Prairie Island Nuclear Generating Plant Units 1 and 2
Dockets 50-282 and 50-306
License Nos. DPR-42 and DPR-60

Response to Requests for Additional Information (RAI) Associated with Adoption of the Alternative Source Term (AST) Methodology (TAC NOS. ME2609 and ME2610)

Nuclear Regulatory Commission (NRC) Request for Additional Information (RAI)

**Figure 11: SGTR Supplemental Input to Dose Evaluation
RCS and Secondary Pressures**

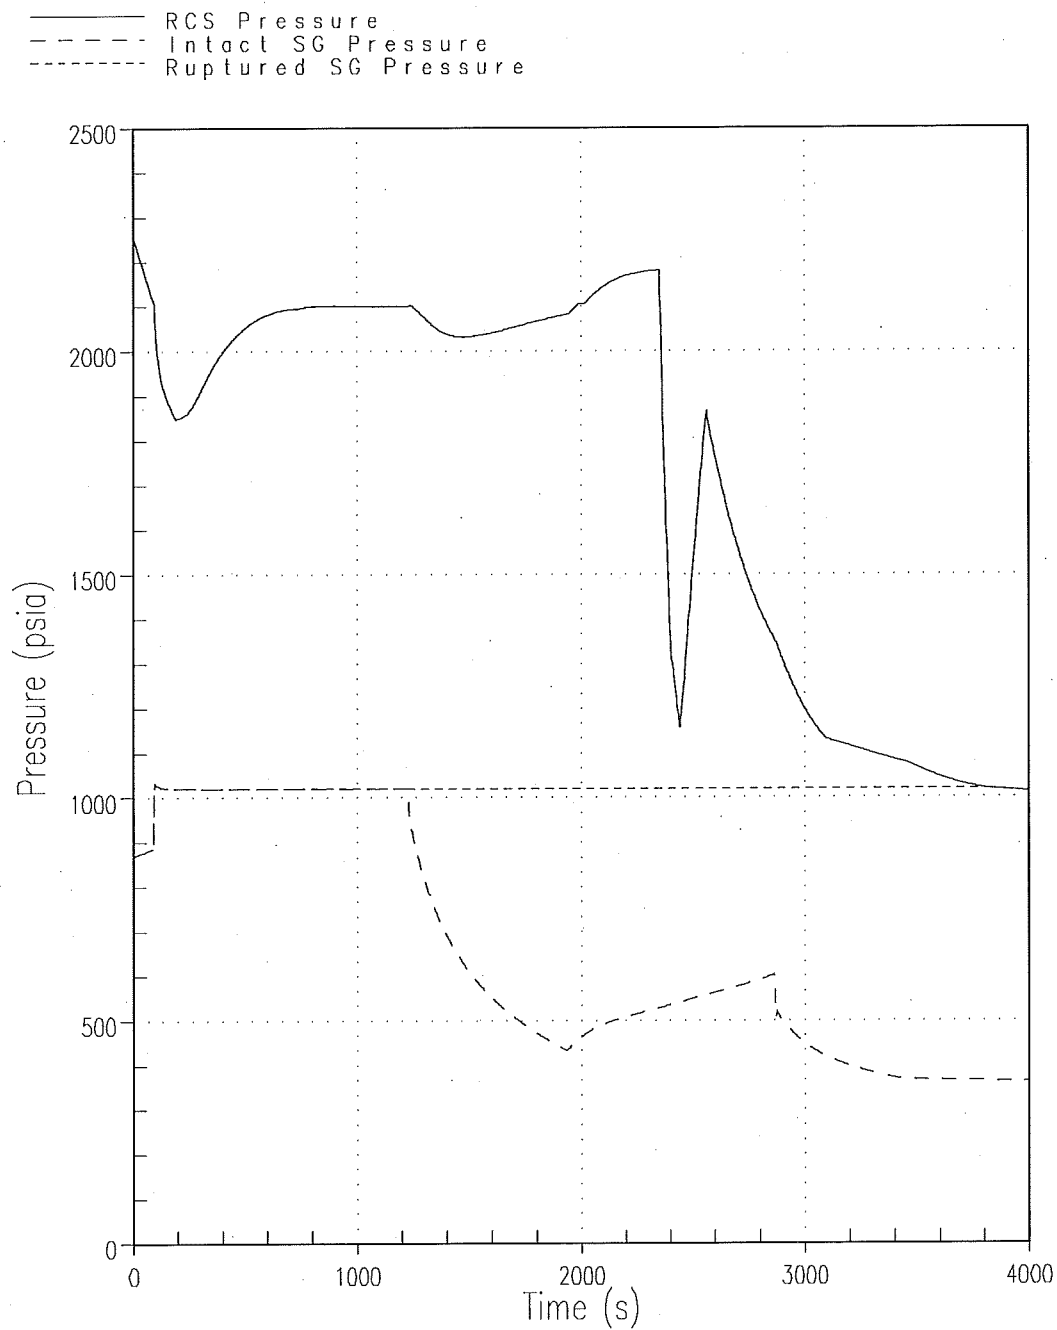
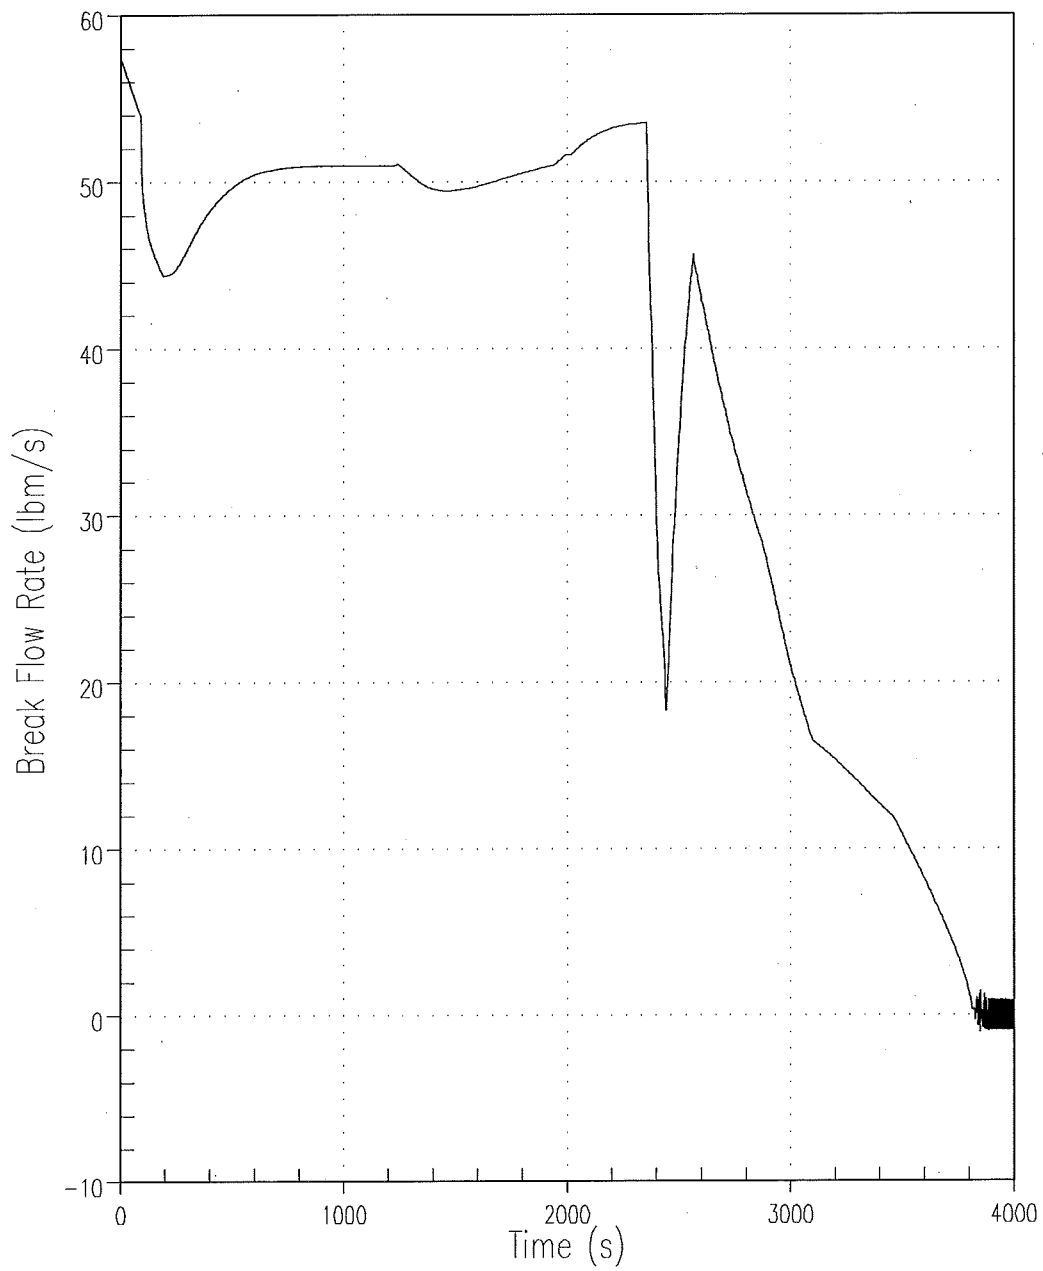
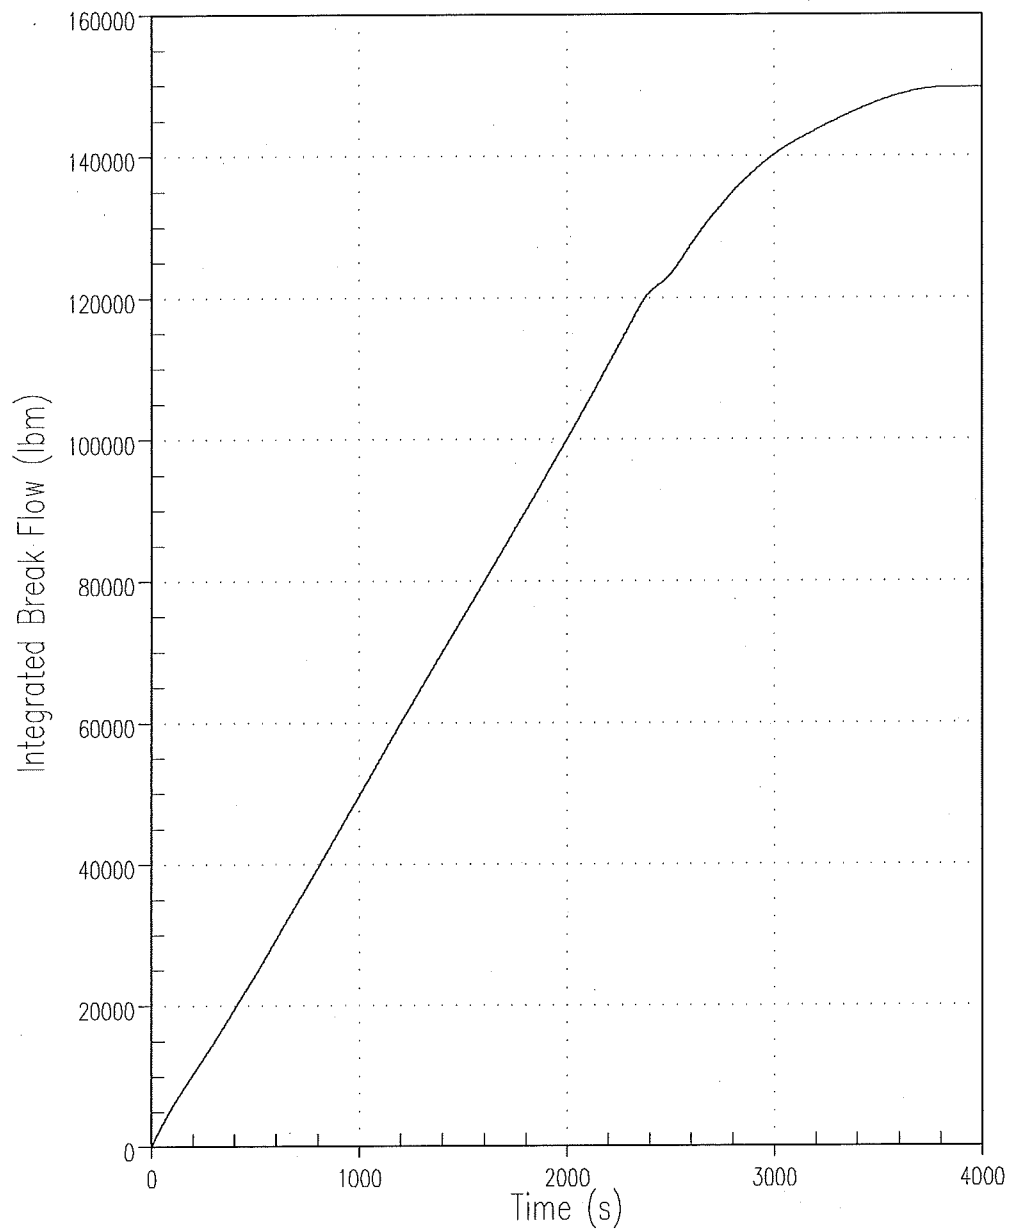
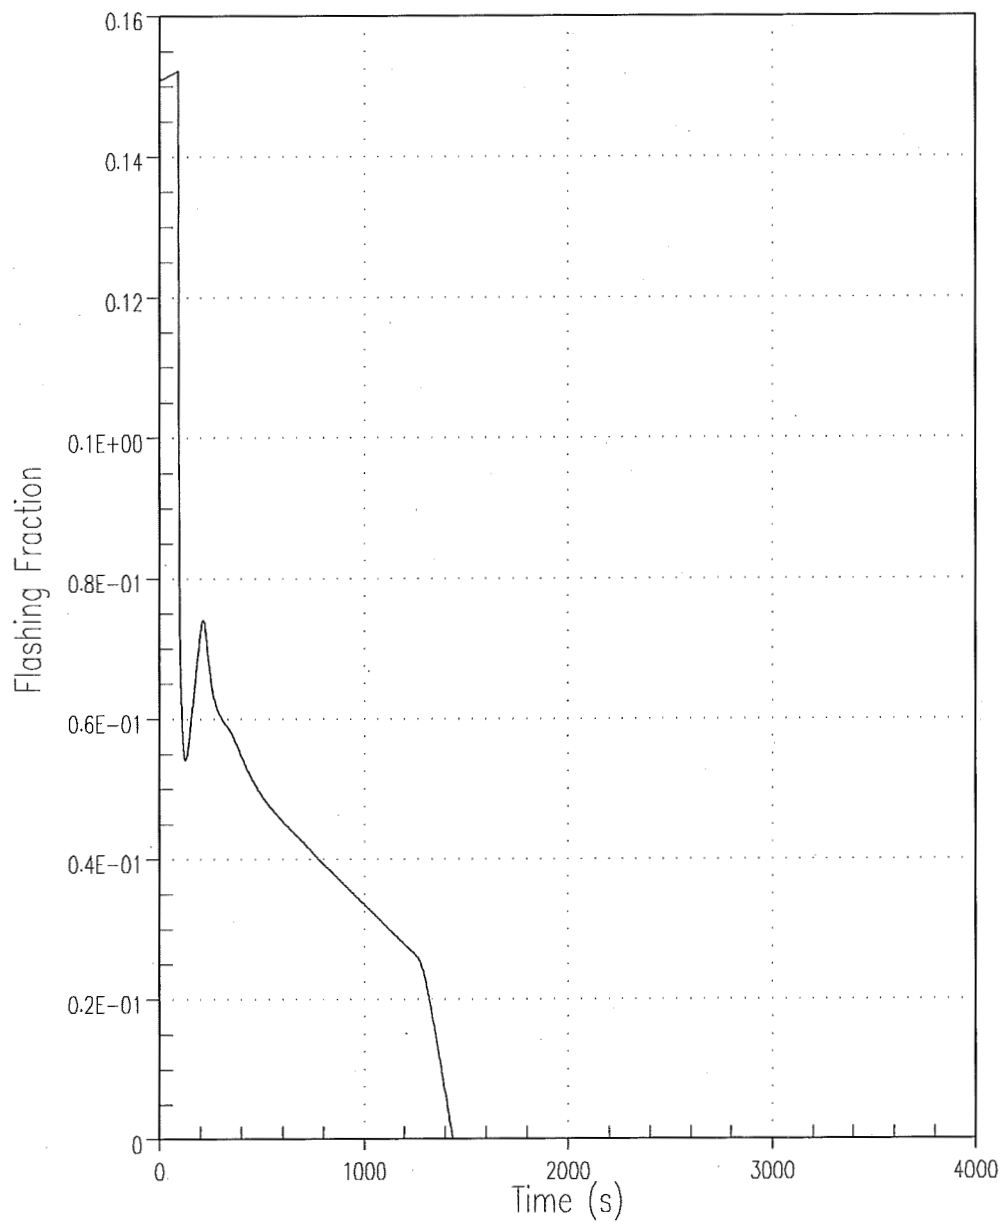
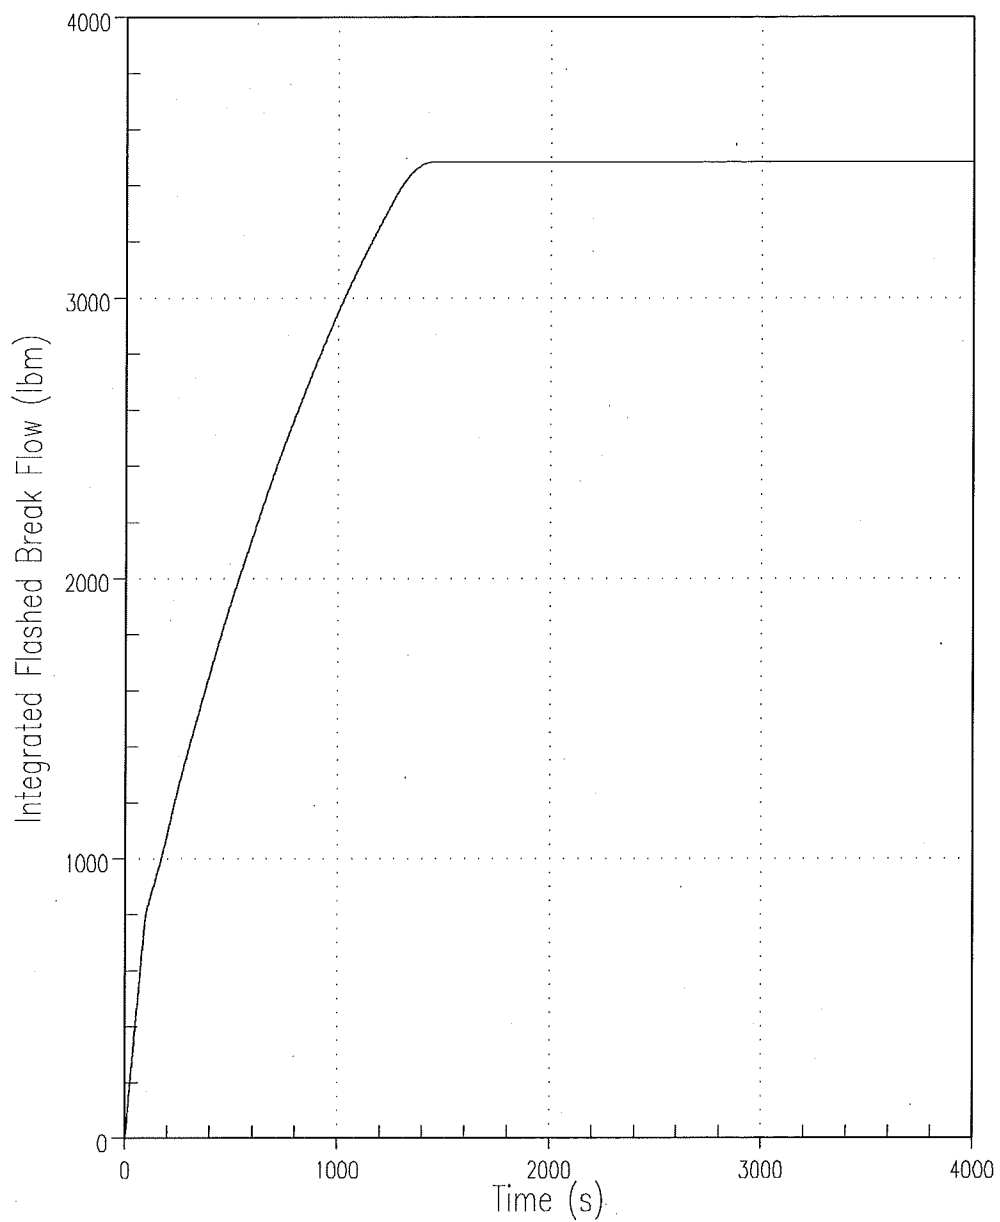
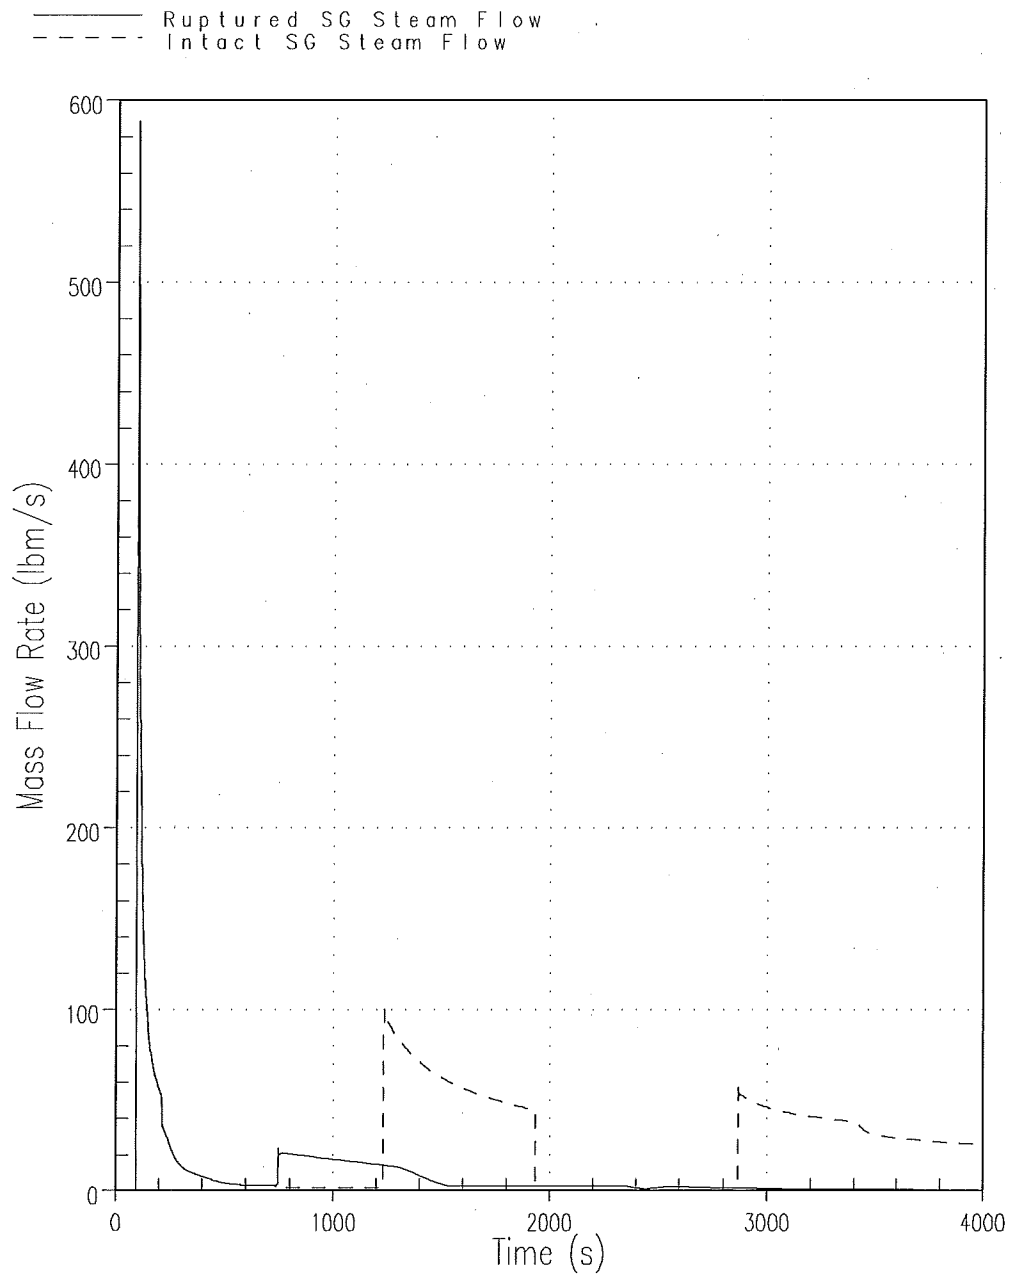
Provide a discussion of the Westinghouse SGTR analysis for mass releases determination and verify that the methods used in the analysis are NRC- approved methods, and address compliance with restrictions and conditions specified in the NRC safety evaluation report approving the methods and computer codes. The requested information should also include the plant parameters considered in the analysis, identify the major input initial conditions and the worst single failure used in the analysis, discuss the bases used to select the numerical parameters and demonstrate that the numerical values with consideration of the uncertainties and fluctuations around the nominal values are conservative, resulting in maximum mass releases during an SGTR event. The results to be provided should include sequences of the event with specification of operator actions, associated times credited in the analysis and their bases for acceptance, and the response of key parameters versus time.

Following the tube rupture, the RCS pressure decreases as shown in Figure 11 due to the primary-to-secondary break flow. In response to this depressurization, the reactor trips on overtemperature- ΔT at approximately 89 seconds. The main feedwater flow was assumed to be terminated and AFW flow was assumed to be automatically initiated with a maximum delay following reactor trip and the coincident LOOP. After reactor trip, core power rapidly decreases to decay heat levels and the RCS depressurization becomes more rapid. The steam dump to condenser system is inoperable due to the assumed LOOP, which results in the secondary pressure rising to the steam generator PORV setpoint as shown in Figure 11. The decreasing pressurizer pressure leads to an automatic SI signal on low pressurizer pressure at approximately 192 seconds. Following SI initiation, the high head safety injection (HHSI) flow begins to restore the reactor coolant inventory and the RCS pressure trends toward the equilibrium value where the SI flow rate equals the break flow rate. After the SGTR and reactor trip, the following operator actions are modeled to mitigate the SGTR event.

Table 8 contains a comparison of the thermal hydraulic mass transfer results for the 30-minute licensing basis hand calculation input to dose analysis to the supplemental thermal hydraulic input to dose analysis. The calculated sequence of events is presented in Table 7. Figures 11 through 16 contain plant transient responses to the tube rupture event including primary and secondary pressure, primary-to-secondary break flow, primary-to-secondary flashing fraction, and secondary steam releases. Conservatism was added to the reported results to cover plant changes that may impact the SGTR analysis, such that a recalculation does not need to be performed for minor changes to the plant. Note that Figures 11 through 16 do not reflect the added conservatism.
